RECEIPT DATE: 5-9-19 **ONSITE SEWAGE DISPOSAL SYSTEM**

APPROVAL DATE: 07/30/2019 **PERMIT: CONSTRUCTION**

PROPERTY ADDRESS: 5529 Jacks Landing Way

SUBDIVISION: Jack's Landing

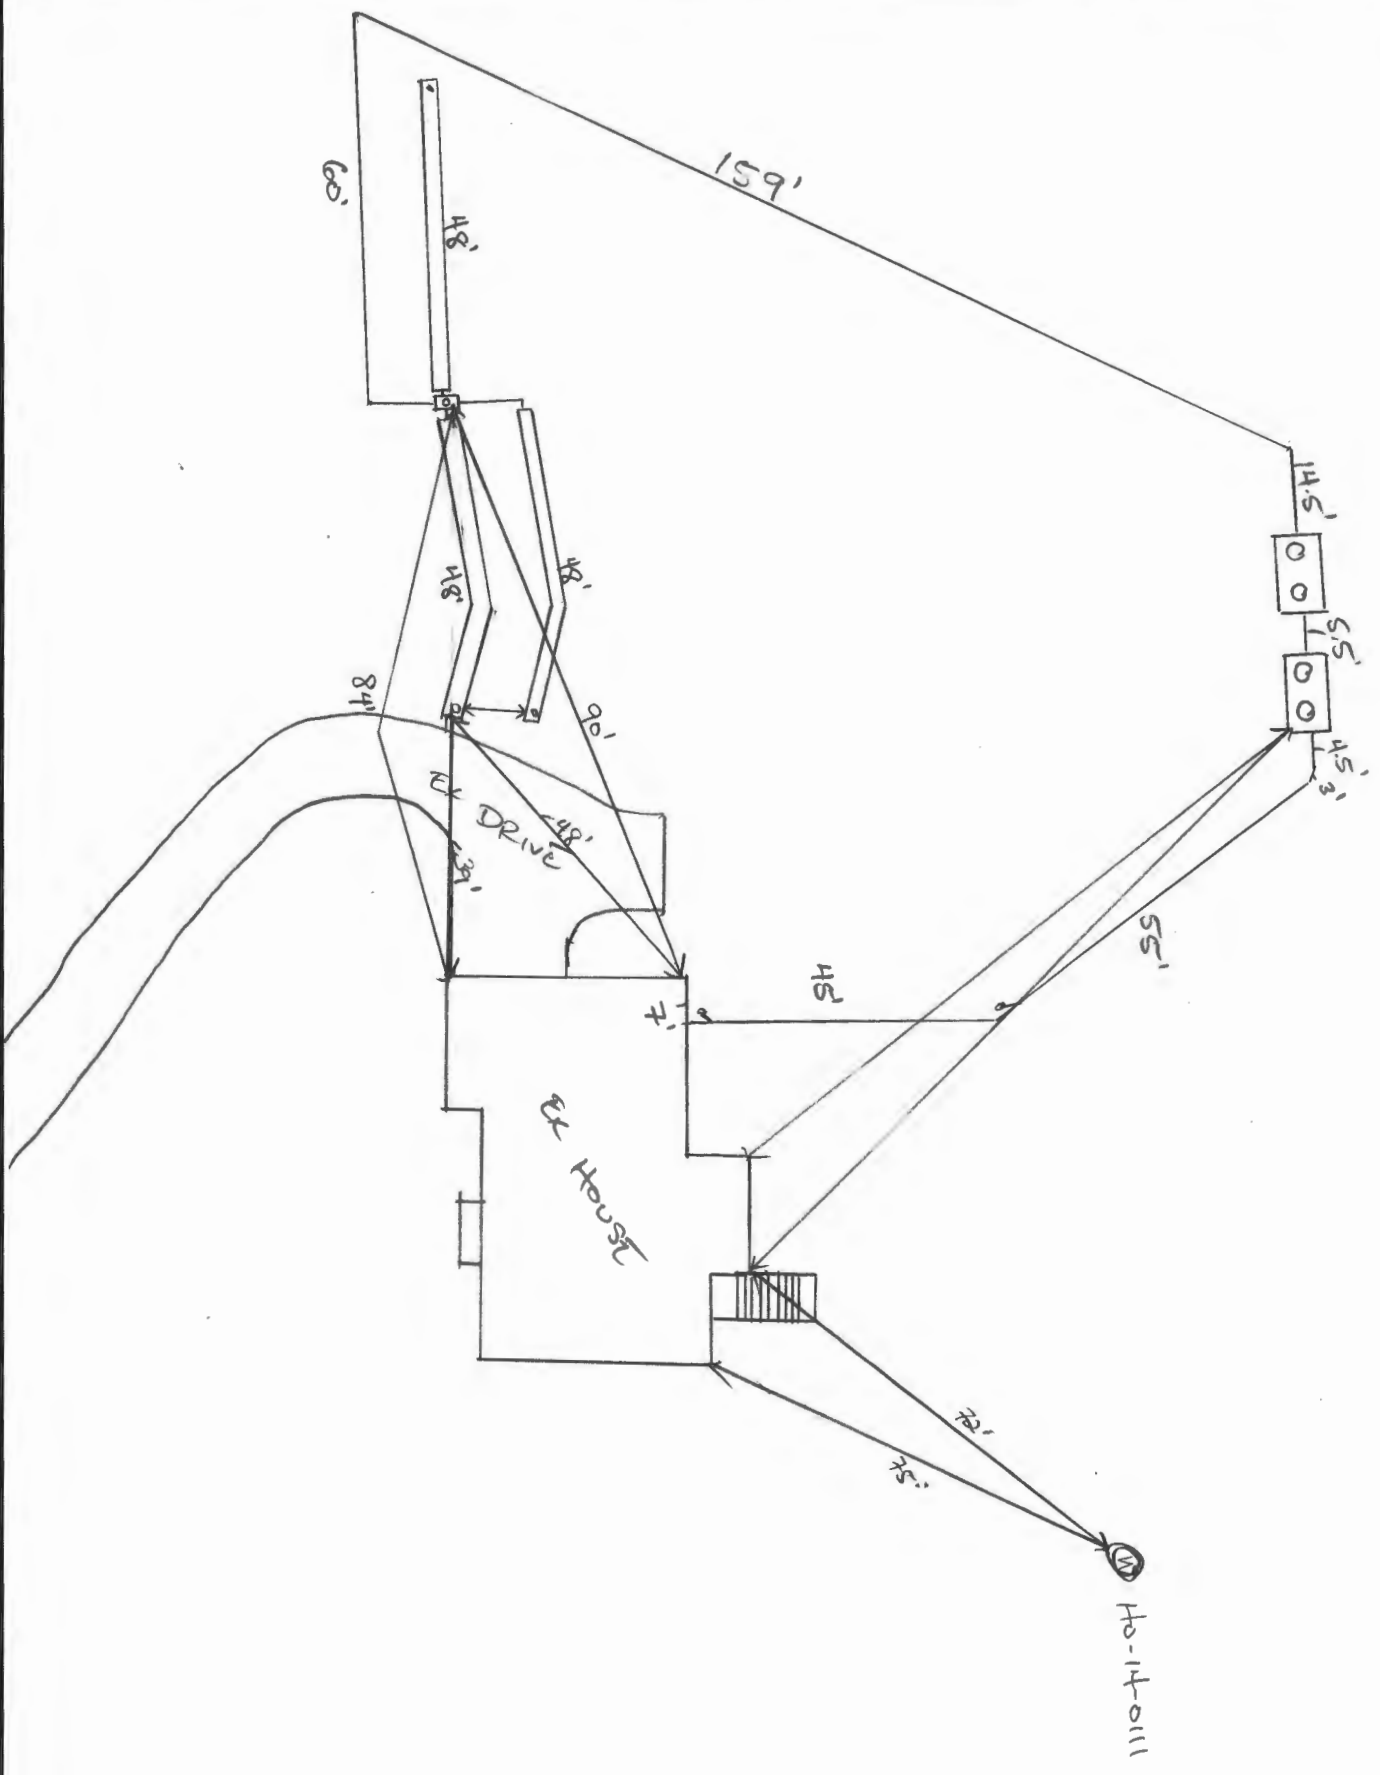
7/23/2019 LAYOUT OK. TANK, SDA, TRENCHES STAKED. SDA HAS LARGE FILL ON TWO TRENCHES PROXIMAL TO HOUSE. USE LASER LEVEL FROM CENTER OF TRENCHES. (+)

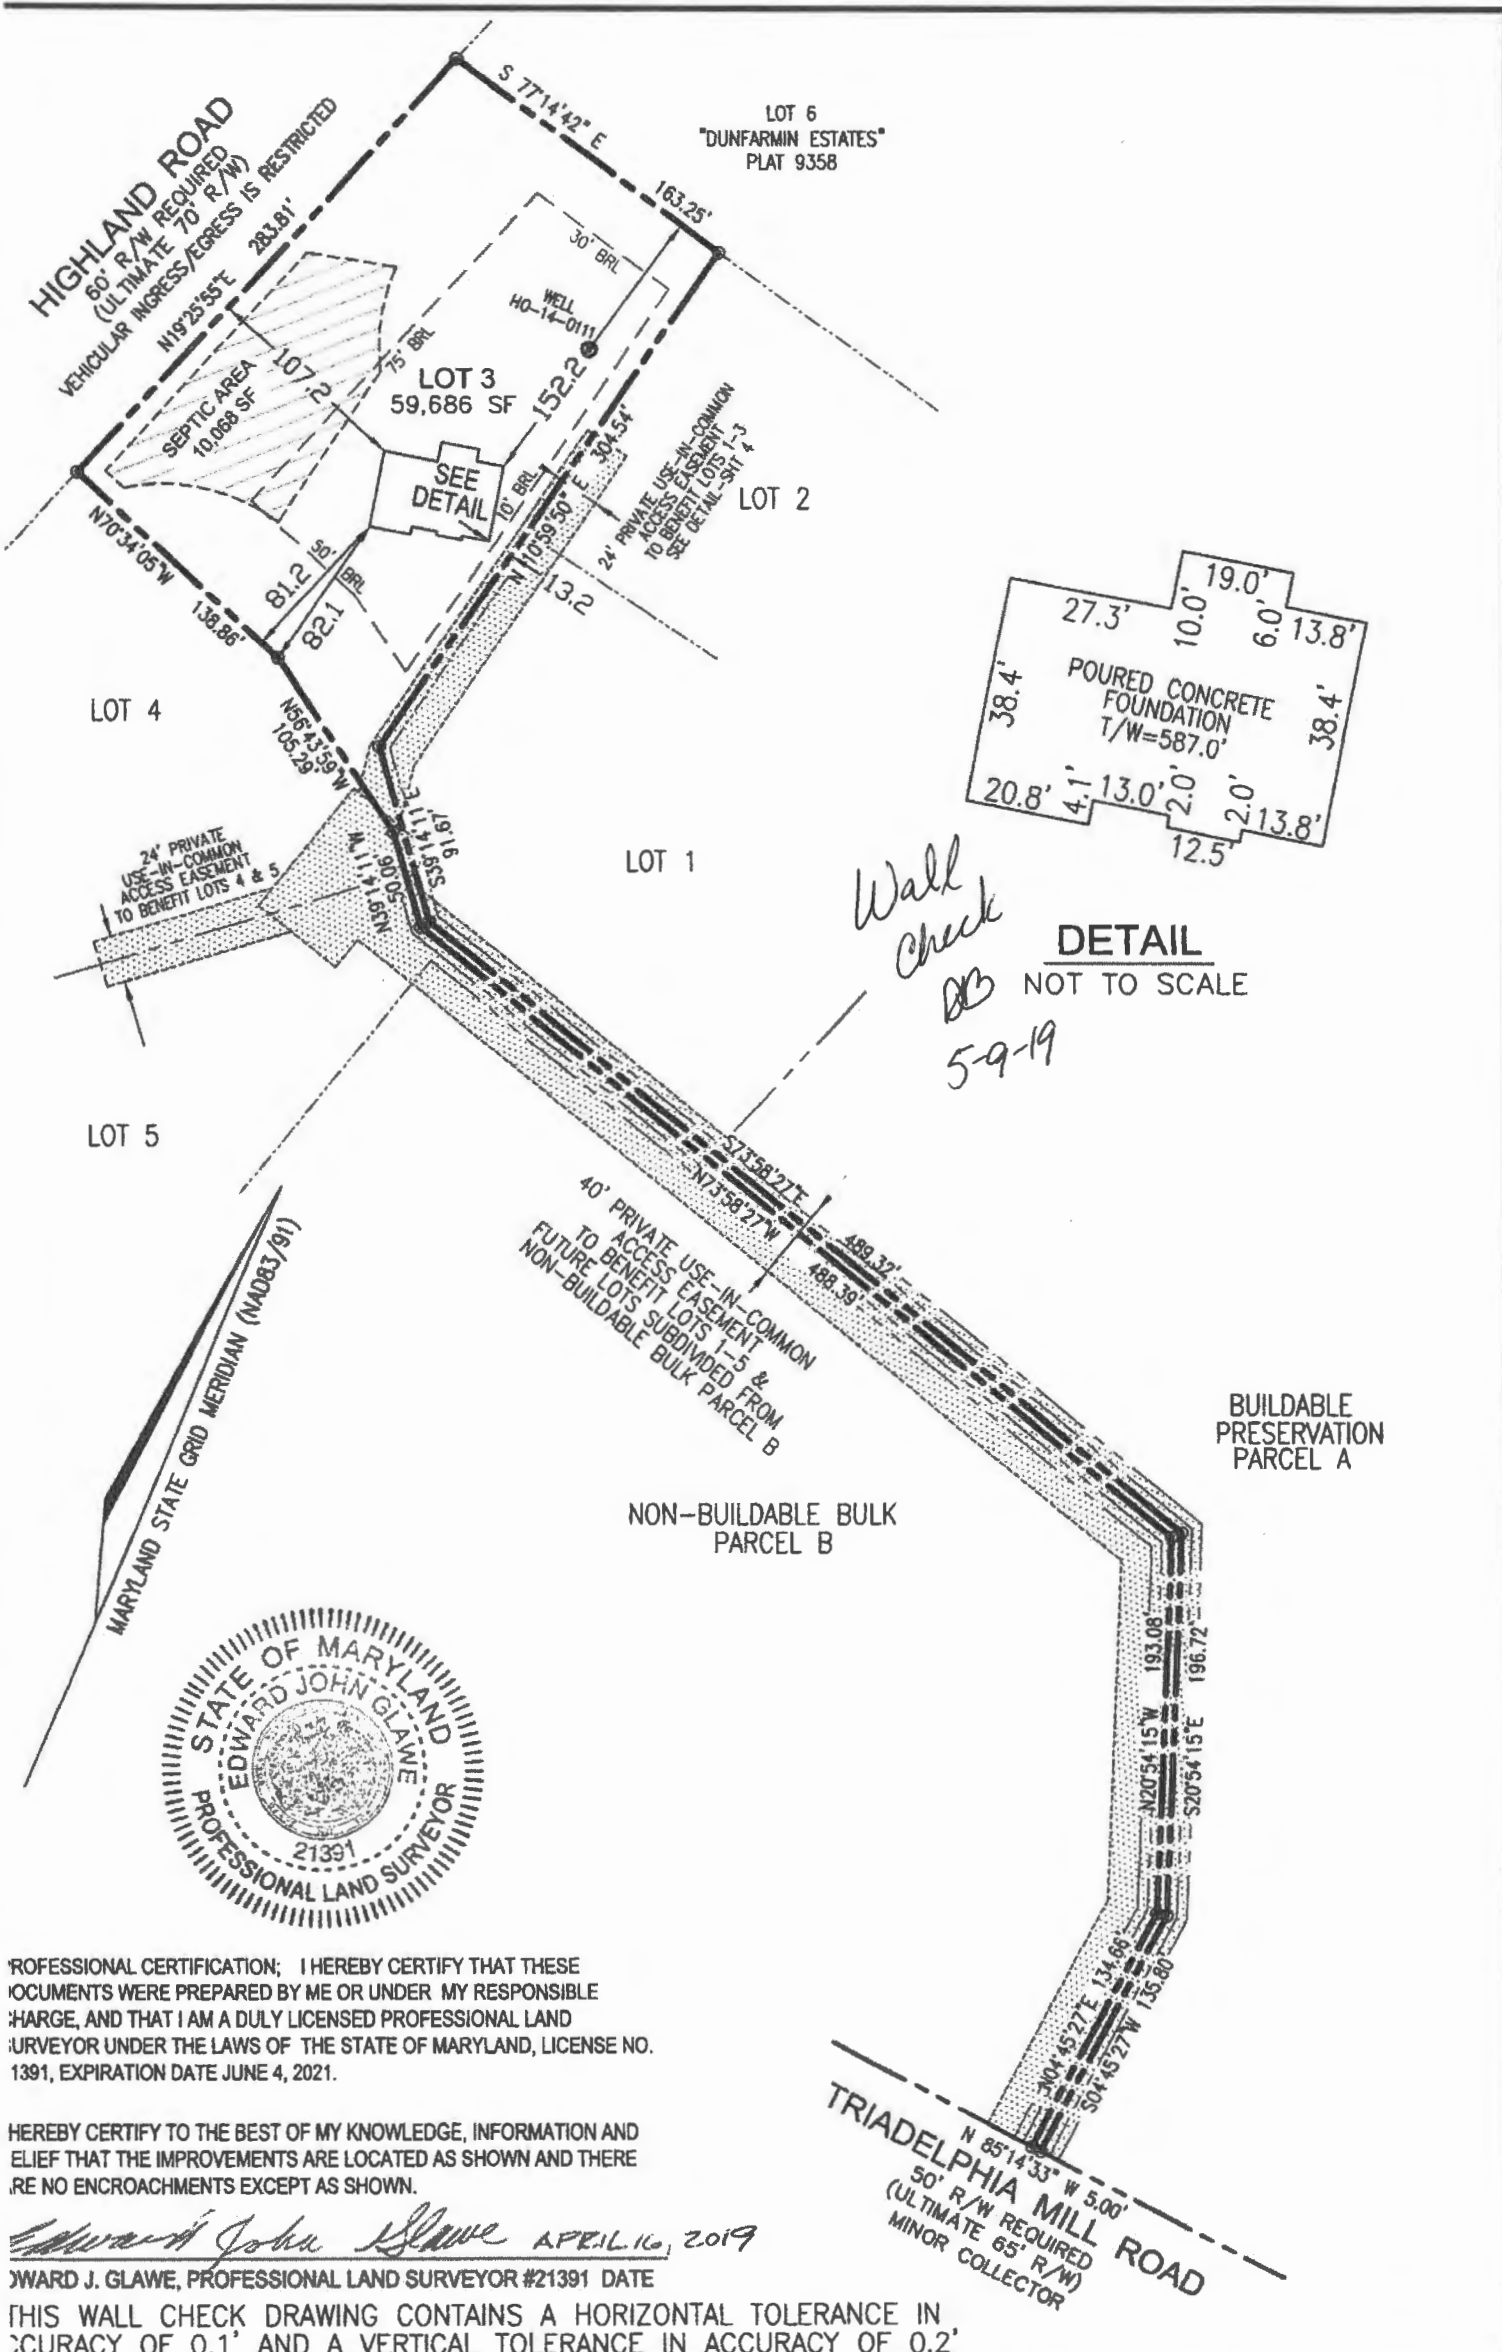
INSTALLATION: 7/23/2019 UPPER DISTAL TRENCH INSTALLED. (+) 7/24/2019 (AM) UPPER PROXIMAL TRENCH OPEN INSPECTION. CONFIRMED BOTTOM DEPTH THROUGH FILL. (+) (PM) TRENCH COMPLETED. (+) 7/26/2019 LOWER TRENCH COMPLETE. OK THROUGH FILL. SHC INSTALLED. TANKS SET. (+) 7/29/2019 FORCE MAIN INSTALLED. REINSF. P/A. (+) 7/30/2019 ALARM FUNCTIONS. PUMP FUNCTIONS. ON SEP. BREAKERS. KNOCK OUT BAFFLE AND GO DOWN INTO BOX. (+)
